From: Pederson Ronda M (AREVA NP INC) [Ronda.Pederson@areva.com]
Sent: Monday, July 13, 2009 6:04 PM
To: Tesfaye, Getachew
Cc: BENNETT Kathy A (OFR) (AREVA NP INC); DELANO Karen V (AREVA NP INC); NOXON David B (AREVA NP INC)
Subject: Response to U.S. EPR Design Certification Application RAI No. 234, FSARCh. 19 (Part 1 of 4)
Attachments: RAI 234 Response US EPR DC (Part 1 of 4).pdf

Request for Additional Information No. 234

U. S. EPR Standard Design Certification

SRP Section: 19 - Probabilistic Risk Assessment and Severe Accident Evaluation

Figure 19-307-1—U.S. EPR Containment Finite Element Model

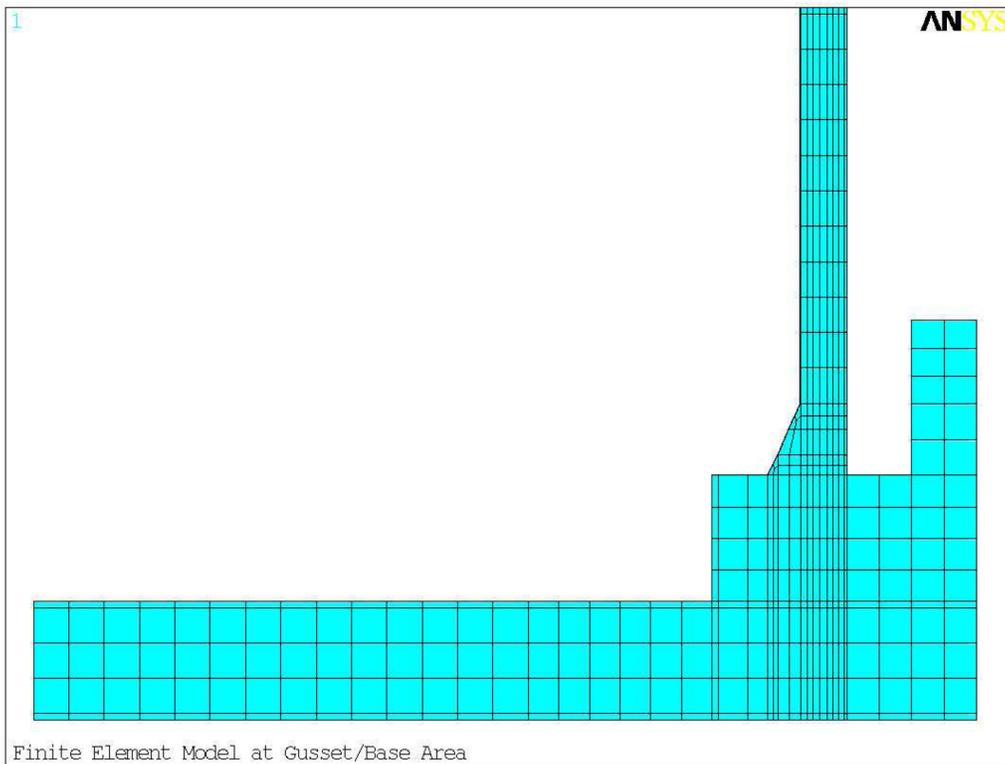
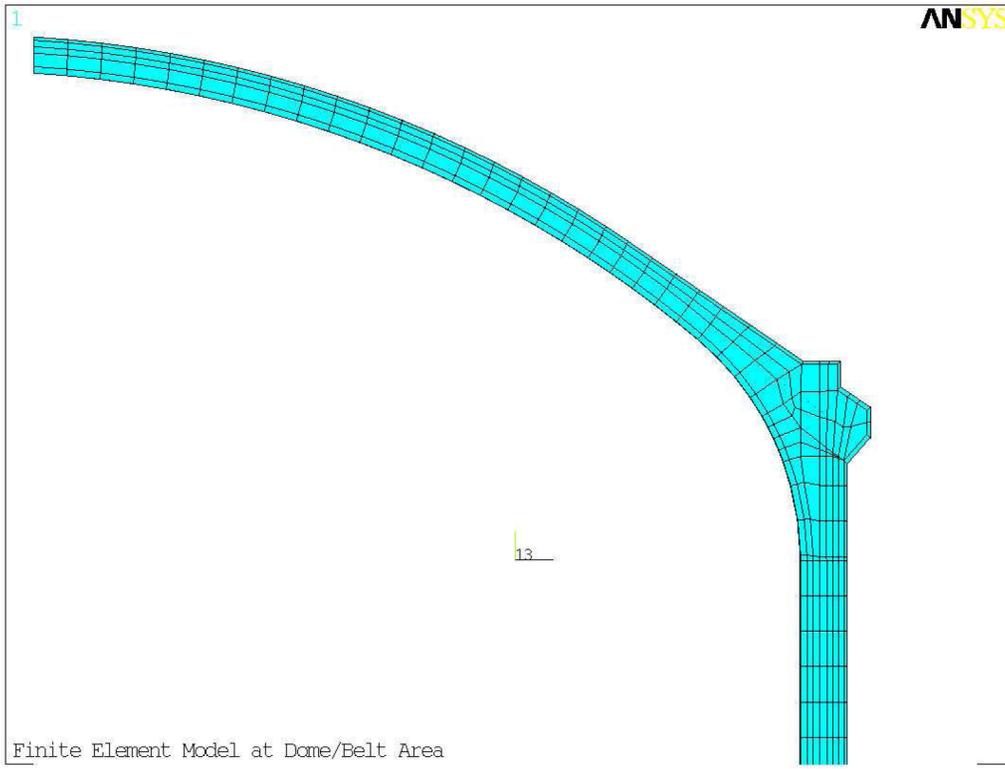
In the response to RAI 19.01-10, the applicant stated that the composite fragility was calculated based on six containment failure modes. Based on the equation provided for determining failure probability, any additional failure modes identified for the containment would increase the containment failure probability. The applicant did not provide any justification for excluding other possible failure modes.

The applicant set the failure criterion for the tendons at 3% strain; however, the applicant did not explain what it means in the context of probability for developing the containment fragility nor did it define what the failure means for other structural components. The manner in which the information is presented in Table RAI 19.1-10-1 and Table RAI 19.1-10-2 was very confusing. Aside from that, the modeling uncertainty was not even mentioned.

The U.S. EPR containment is sub-divided into six areas, which, when assembled together represent a continuous model of the entire containment structure. These areas are the cylindrical wall, spherical dome, dome belt, gusset (the connection from the wall to the foundation) and the equipment hatch (horizontal and vertical sections). Major penetrations, and personnel and emergency airlocks are not currently modeled because design details for these will be developed later in the design process. The boundaries of the six areas modeled are selected so that each area covers a pressure boundary location in the containment, and for each one the most limiting failure mode is analyzed. Table 19-307-1 summarizes the controlling failure mode for each area of the containment. Figure 19-307-1 shows the entire containment model developed with ANSYS (Reference 2).
